ADDENDUM 004

project	SDP Sumitomo Dainippon Pharma TI	project no	21560
date	2021-09-02	no. pages	
owner	SDP Sumitomo Dainippon Pharma Oncology		
contractor			
bid date	2021-09-16	bid time	2:00 pm

item	sheet#	description
4.1	A111.0C	Location of relocated light sensor & ceiling tile
4.2	A111.3	Relocate light & sensor ceiling tile
4.3	ED101B	Relocate light sensor & ceiling tile
4.4	EL101	Location of relocated light sensor & ceiling tile

1 DEMO REFLECTED CEILING PLAN
SCALE: 1/8" = 1'-0"

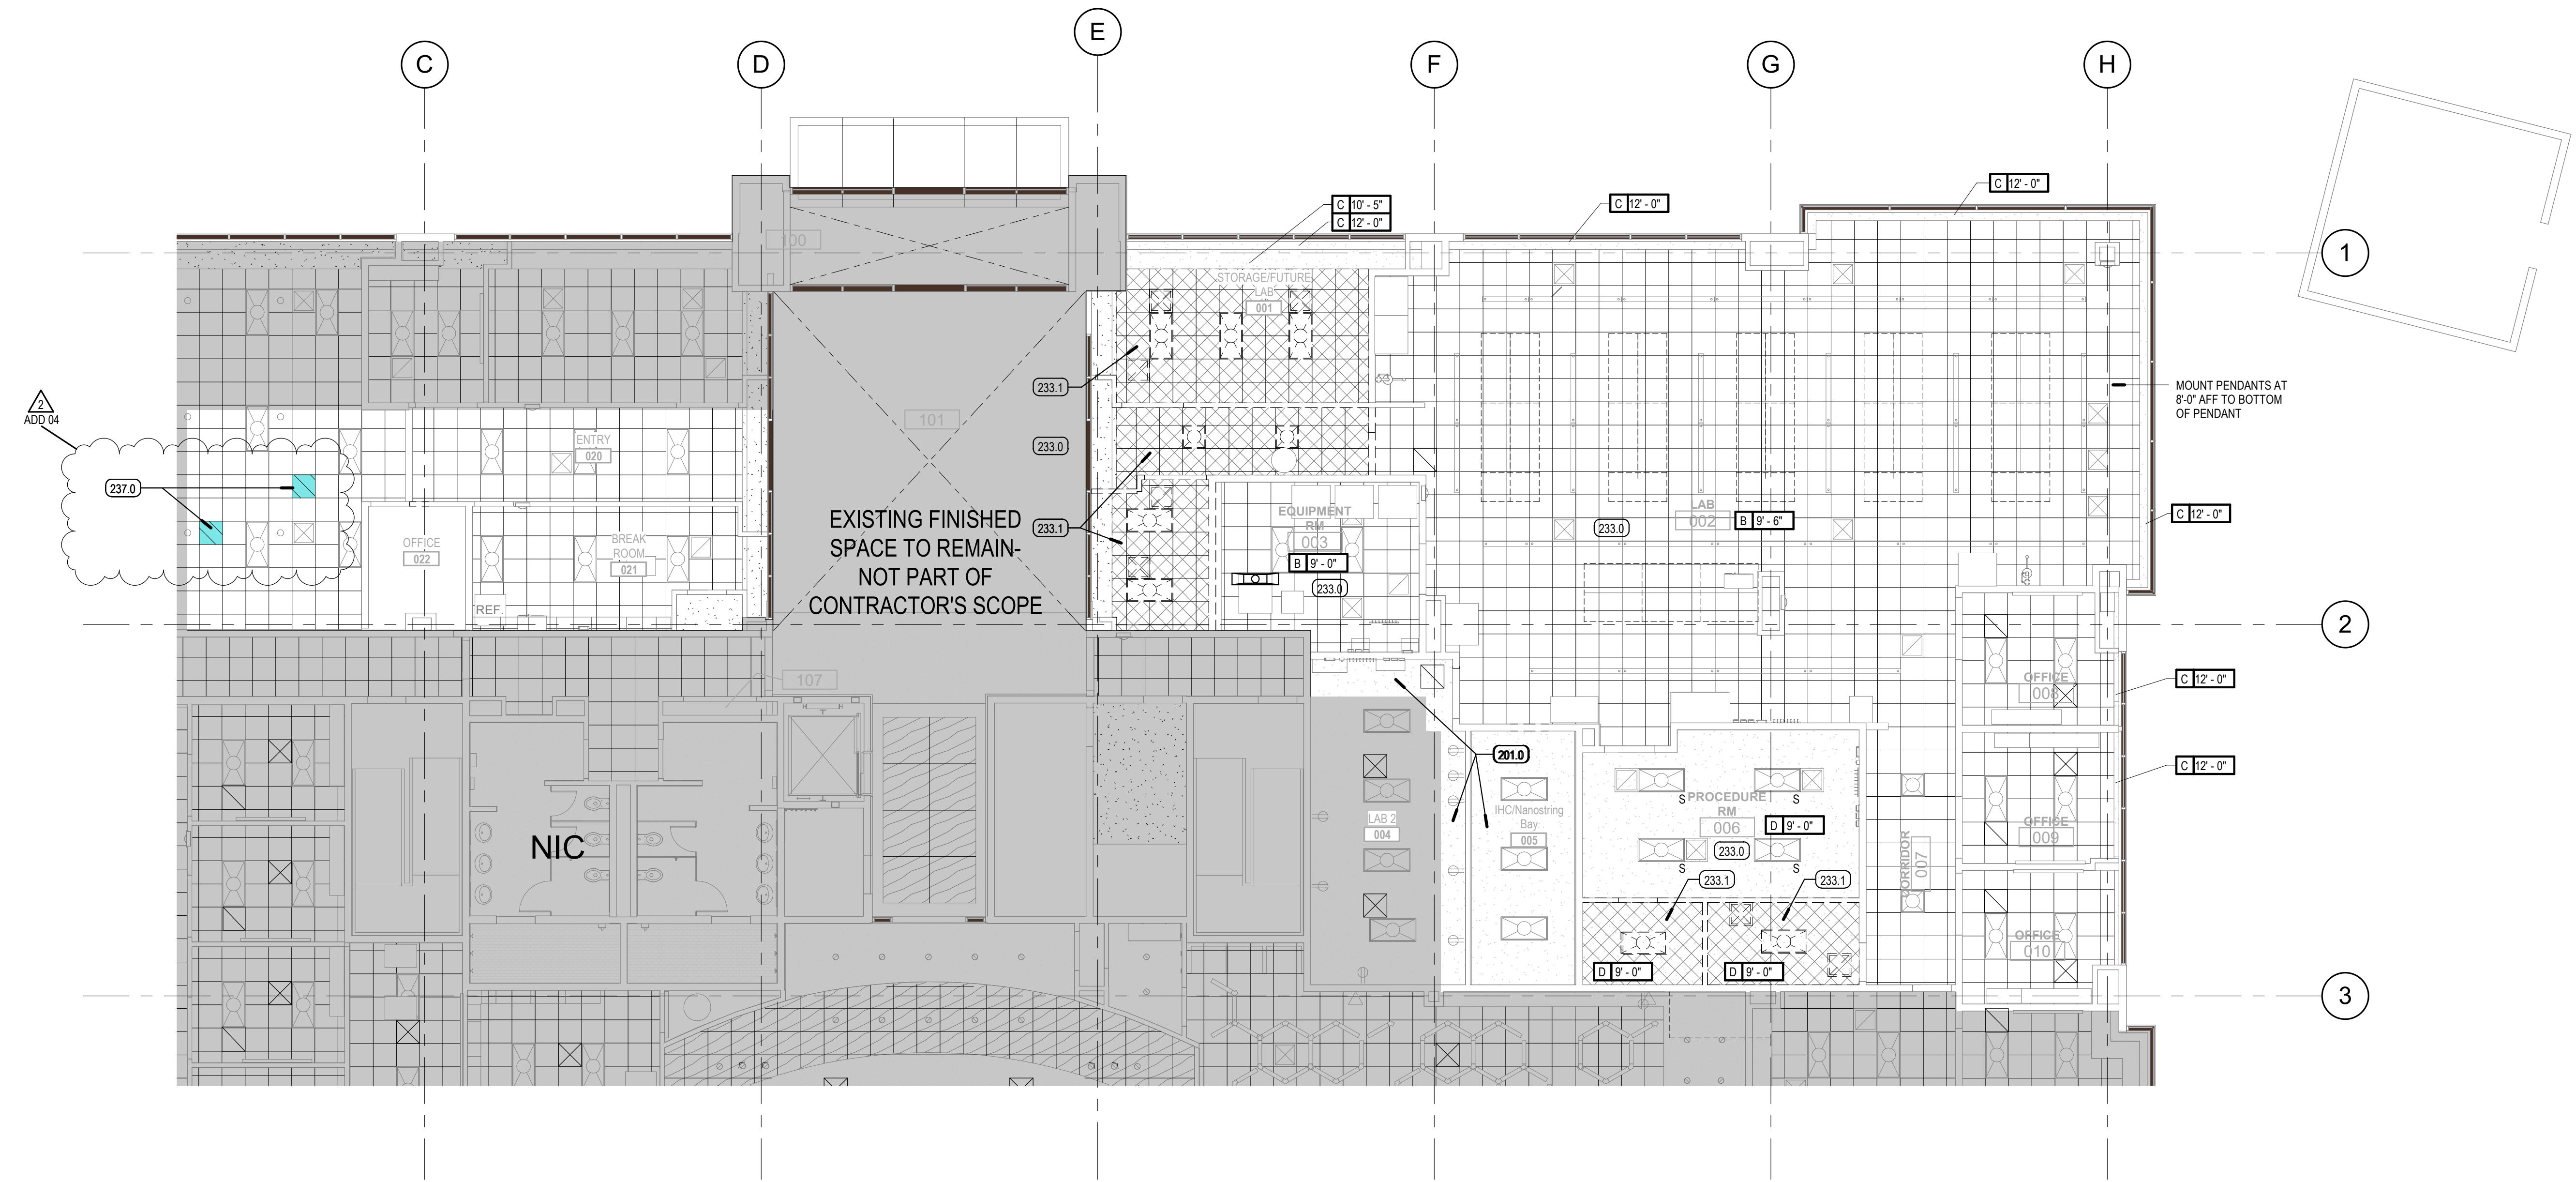
- 201.0 REMOVE EXISTING GYP BD CEILING & FIRE PROOFING TO ENABLE WALLS TO EXTEND TO UNDERSIDE OF DECK
- 233.0 EXISTING CEILING TO REMAIN, PROTECT DURING CONSTRUCTION
- 233.1 REMOVE AND DISCARD CEILING, SALVAGE LIGHT FIXTURES AND DIFFUSERS - SEE REFLECTED CEILING PLAN
- 237.0 REMOVE CEILING TILE WITH LIGHT SENSOR, INSTALL IN NEW LOCATION PER ELEC DWGS. REPLACE WITH OTHER CEILING TILE IT IS REPLACING

1 REFLECTED CEILING PLAN
SCALE: 1/8" = 1'-0"

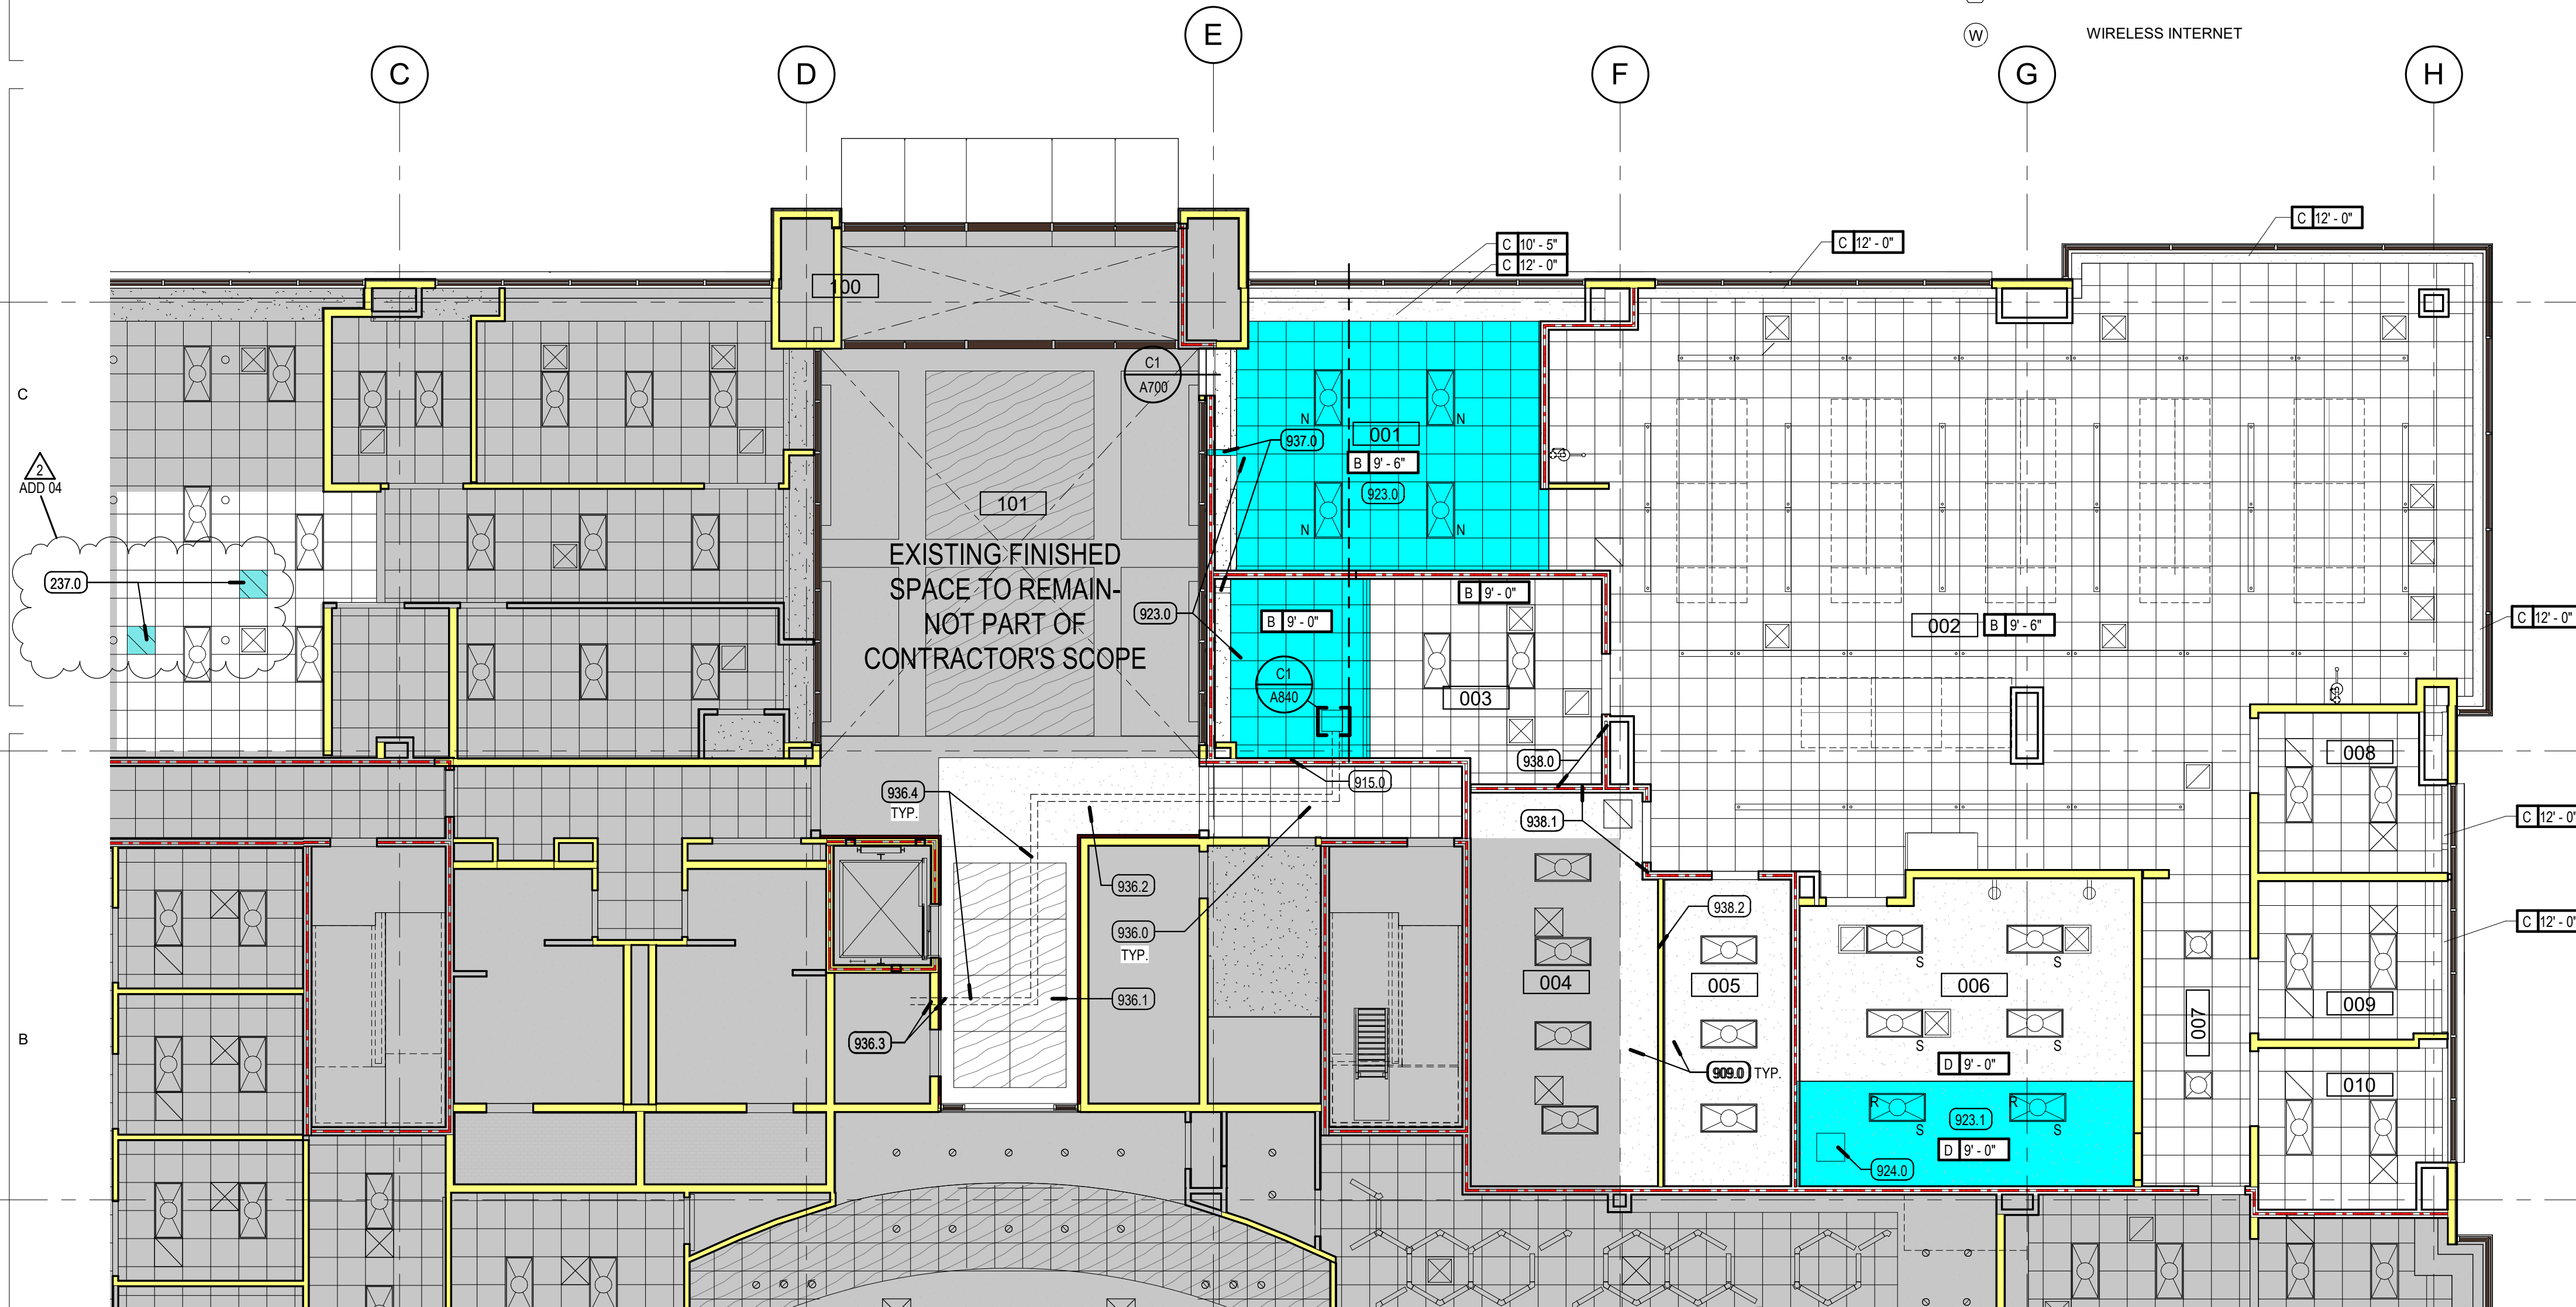
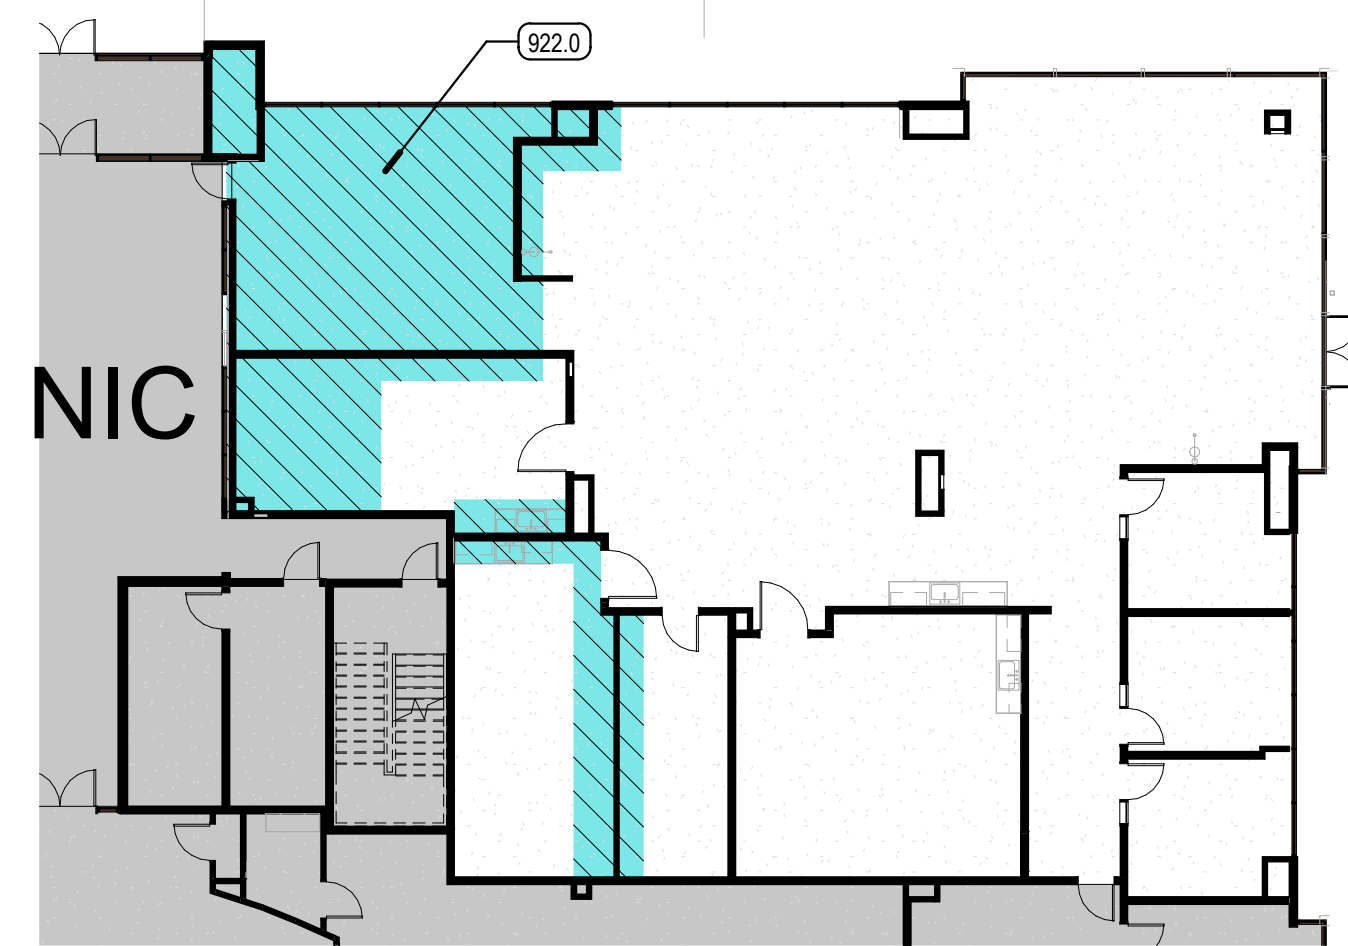
- 237.0 REMOVE CEILING TILE WITH LIGHT SENSOR, INSTALL IN NEW LOCATION PER ELEC DWGS. REPLACE WITH OTHER CEILING TILE IT IS REPLACING
- 909.0 PATCH & PAINT CEILING WHERE REMOVED FOR EXTENSION OF WALL TO DECK, MATCH EXISTING

A1 LEVEL 1 CEILING DEMOLITION PLAN
SCALE: 1/8" = 1'-0"

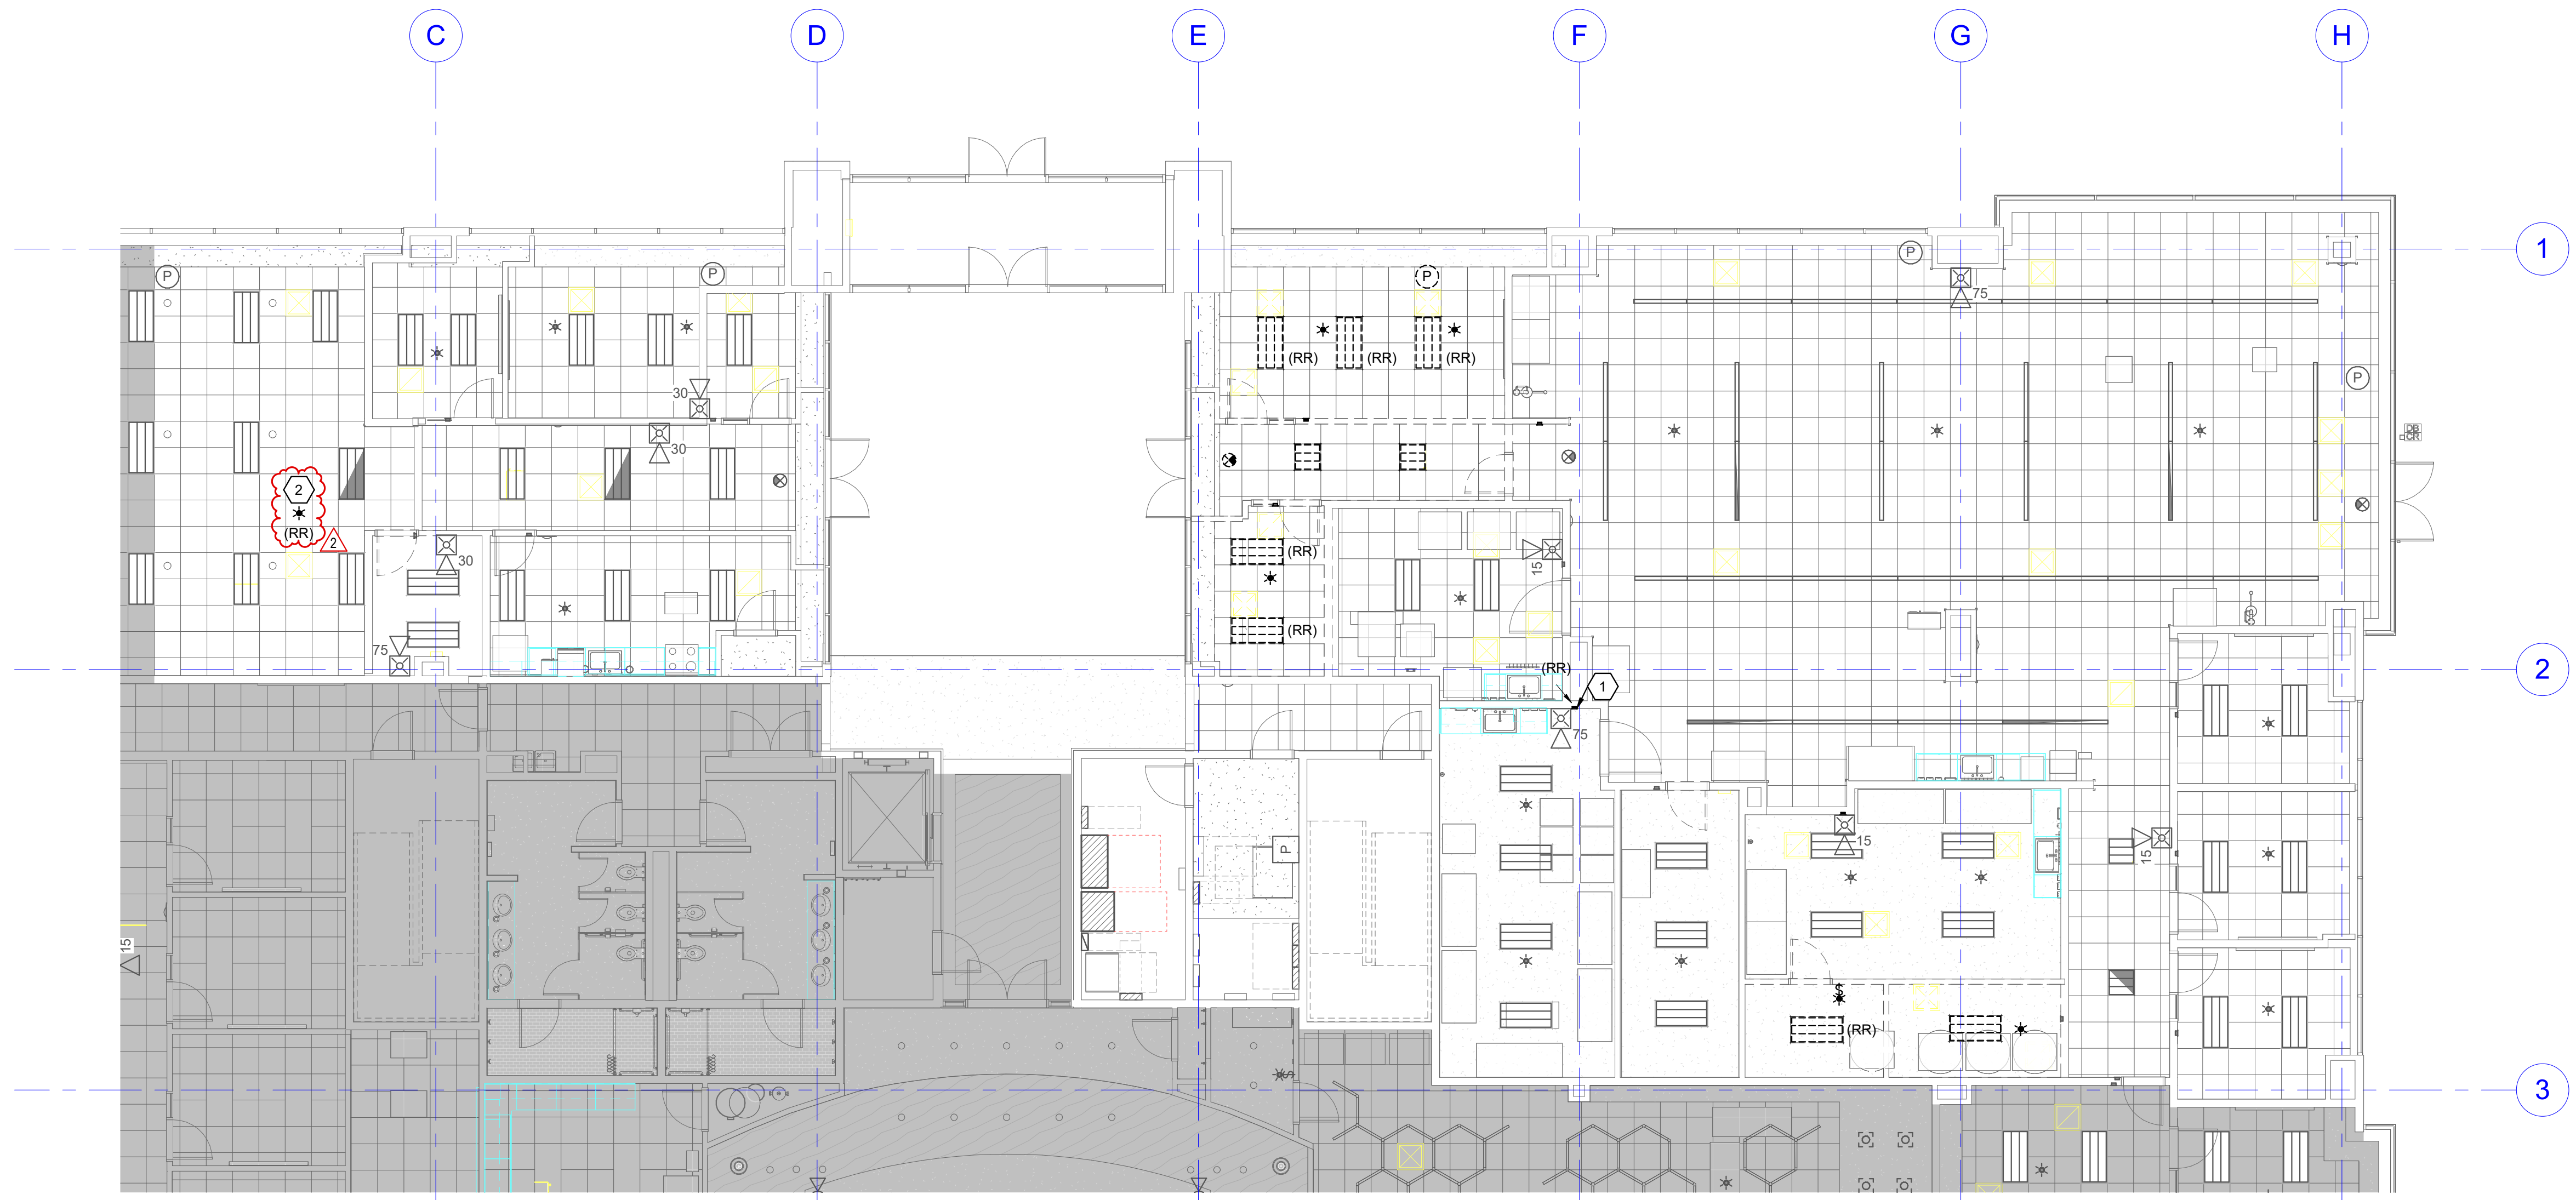
- 1 RELOCATE SWITCH AND CONTROLS PER NEW LIGHTING PLANS.
- 2 RELOCATE LIGHTING SENSOR, COORDINATE EXACT LOCATION WITH OWNER.
